SUBJECT: VE Proposal #1 (Revised)
J2P0771 / J2P0773, Rte. 63, Randolph/Macon/Adair

VE #1 (Revised)

CONSTRUCTION VALUE ENGINEERING CONCEPT PROPOSAL
MISSOURI DEPARTMENT OF TRANSPORTATION

J2P0771/J2P0773, Rte. 63, Randolph, Macon, Adair Co.

SECTION ON TANGENT
 TYPICAL SECTION RTE. 63

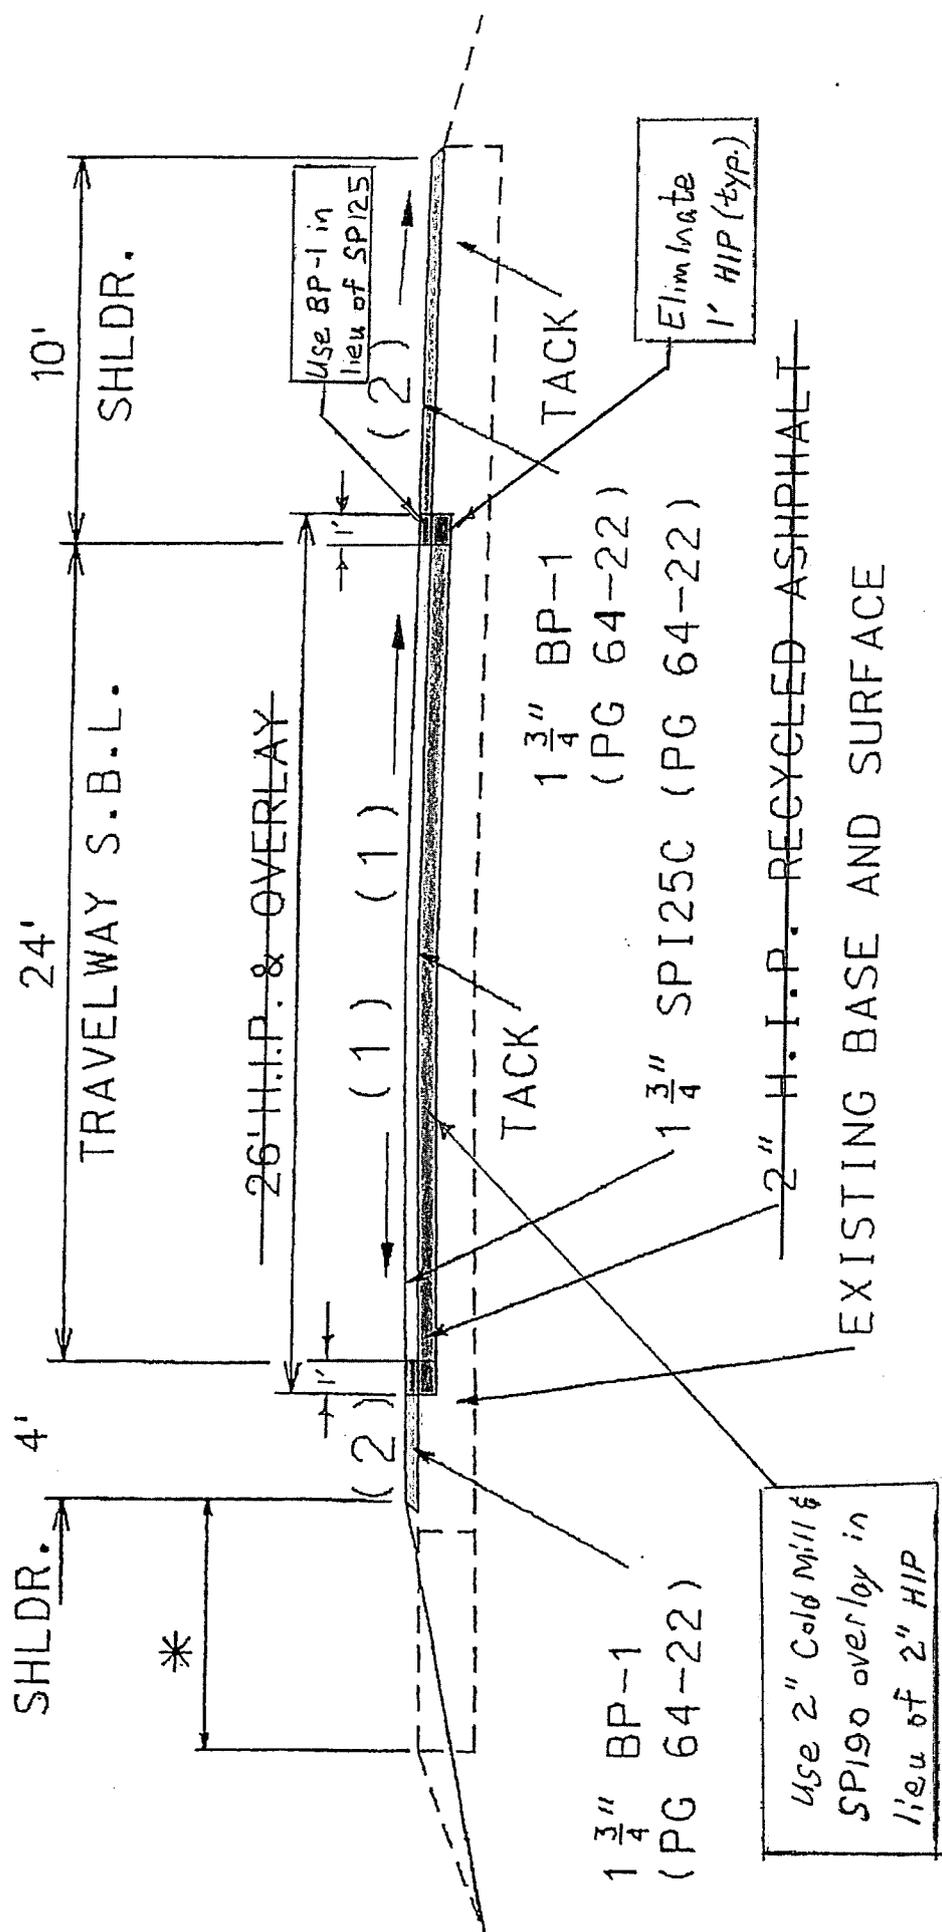
I submitted a revised proposal to APAC that substitutes the overlay in lieu of HIR, but also eliminates the 1-foot strip of HIR on both shoulders. My proposal also changes the surfacing on that 1-foot strip from SP125C to BP-1.

Substitute a 24' wide, 2" cold mill, with 2" SP190C overlay, in lieu of the planned 26' wide Hot-in-Place recycling. Eliminate the 1' wide Hot-in-Place recycling on each shoulder - the contractor would share in 25% of the savings from this underrun. Overlay the 1' strip on each shoulder with BP-1 in lieu of SP125C - the contractor would share in 50% of the savings from using a lower cost mix. See attached spreadsheet and typical section for more detail.
